Project	IEEE 802.16 Broadband Wireless Access Working Group < http://ieee802.org/16 >	
Title	The concept of Idle mode operation in IEEE802.16e	
Date	2004-03-05	
Submitted		
Source(s)	Changhoi Koo, Jungje Son, Yeongmoon Son, Seungil Yoon, Seungeun Hong, Jung-won Kim Samsung Electronic, Suwon P.O.Box 105, 416, Maetan-3dong, Paldal-gu, Suwon-si, Gyeonggi-do, Korea 442-742	Mail to : chkoo@samsung.com , jungje.son@samsung.com , ym1004.son@samsung.com , siyoon72@samsung.com , seungeun.hong@samsung.com , jungwon74.kim@samsung.com
Re:	Call for inputs for commentary of p802.16e/D1	
Abstract	This contribution describes idle mode for IEEE P802.16e/D1-2004.	
Purpose	Discuss and Adopt enhanced feature of p802.16e/D1	
Notice	This document has been prepared to assist IEEE 802.16. It is offered as a basis for discussion and is not binding on the contributing individual(s) or organization(s). The material in this document is subject to change in form and content after further study. The contributor(s) reserve(s) the right to add, amend or withdraw material contained herein.

The Concept of Idle Mode Operation in IEEE 802.16e

Figure XXX Mode Transition diagram of MAC state machine

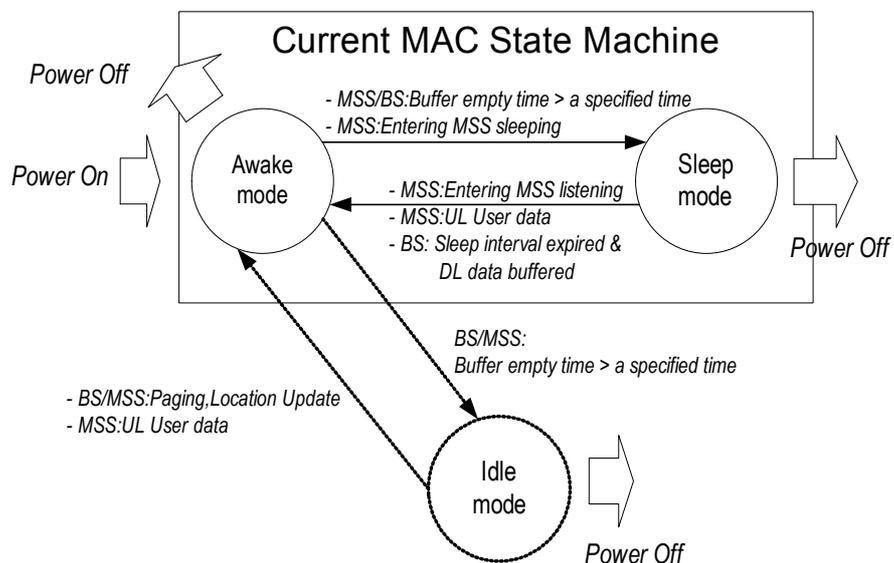
The following figure provides the overview of the MSS and BS modes and mode transitions.

Figure. 108a - MSS Awake Mode SDL Diagram

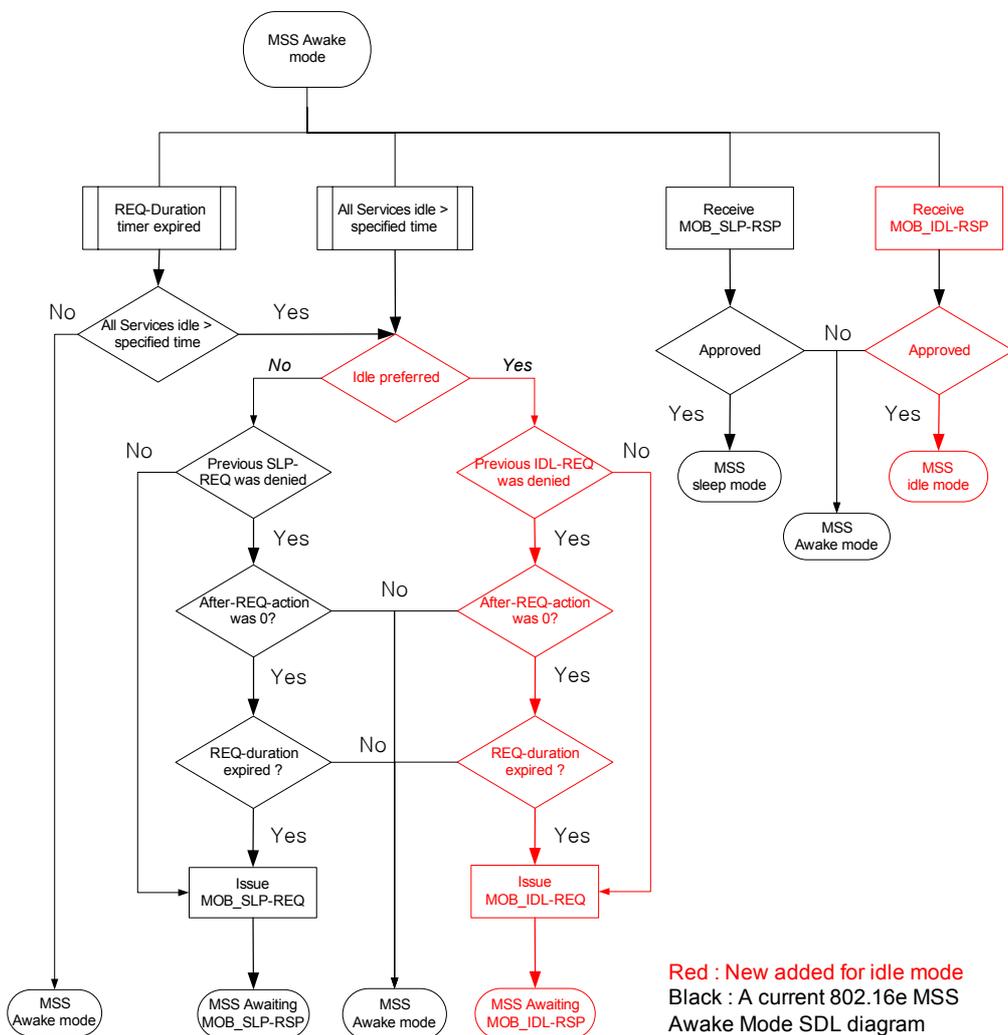
[In Page 37, Line 1, Replace Figure 108a – MSS Awake Mode SDL Diagram with the following]

Figure.108b MSS Awaiting Sleep Response SDL Diagram

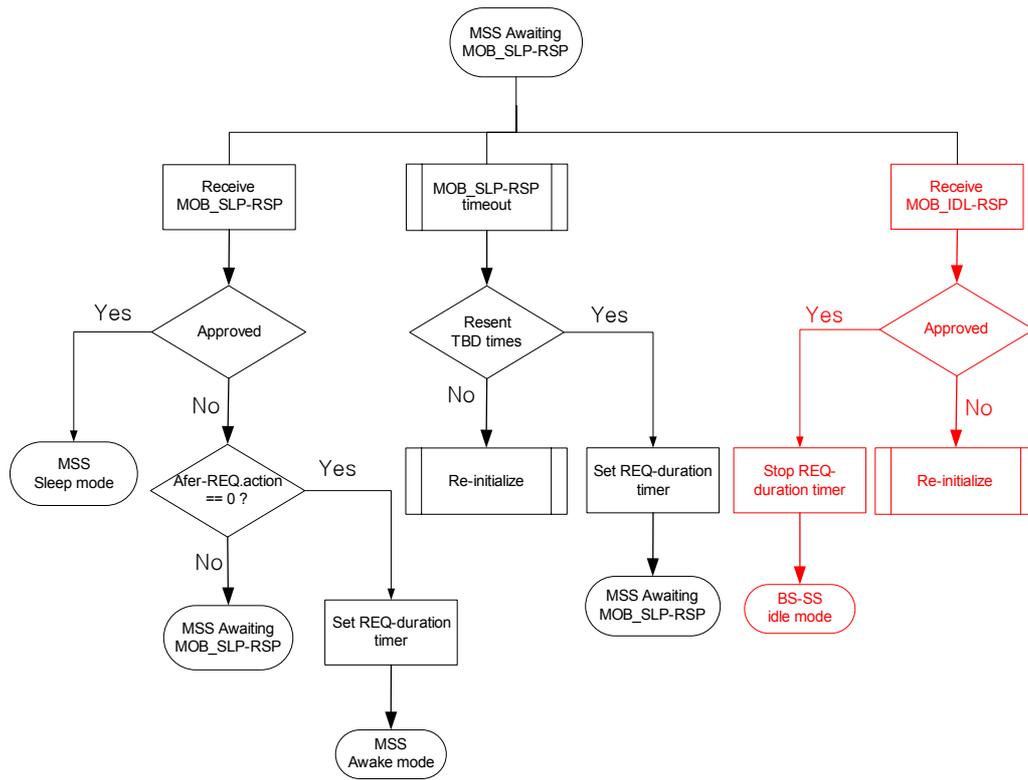
[In Page 38, Line 1, Replace Figure 108b – MSS Awaiting Sleep Response SDL Diagram with the following]

Figure 109d. Typical MSS Listening SDL Diagram

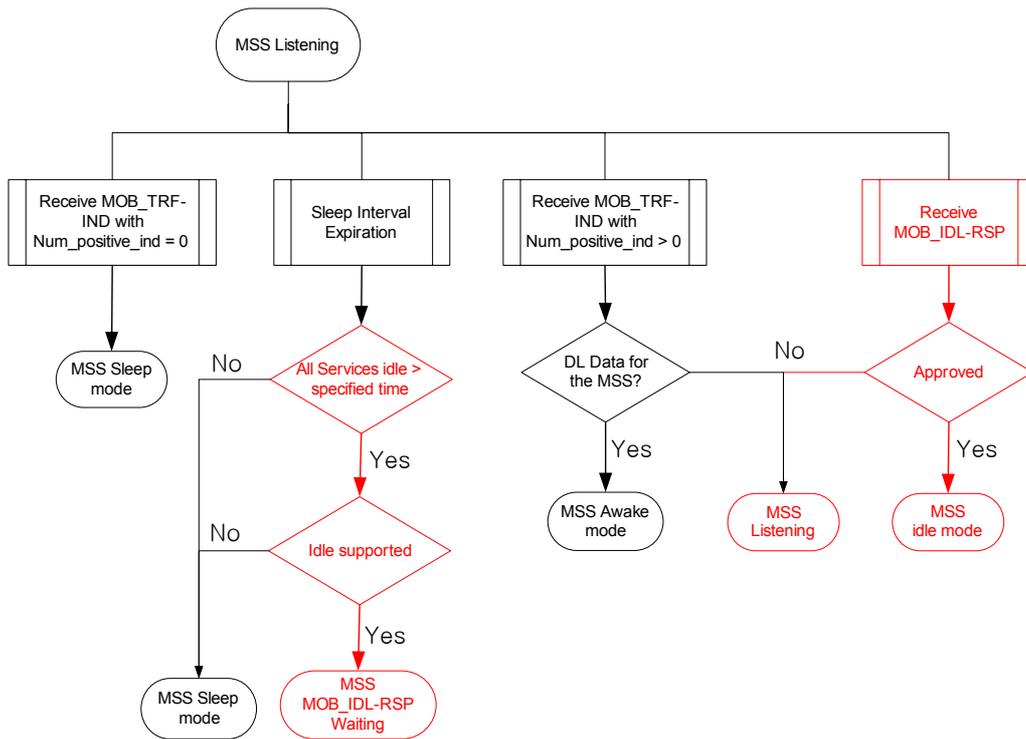
[In Page 38, Line 1, Replace Figure 108d – Typical MSS Listening SDL Diagram with the following]
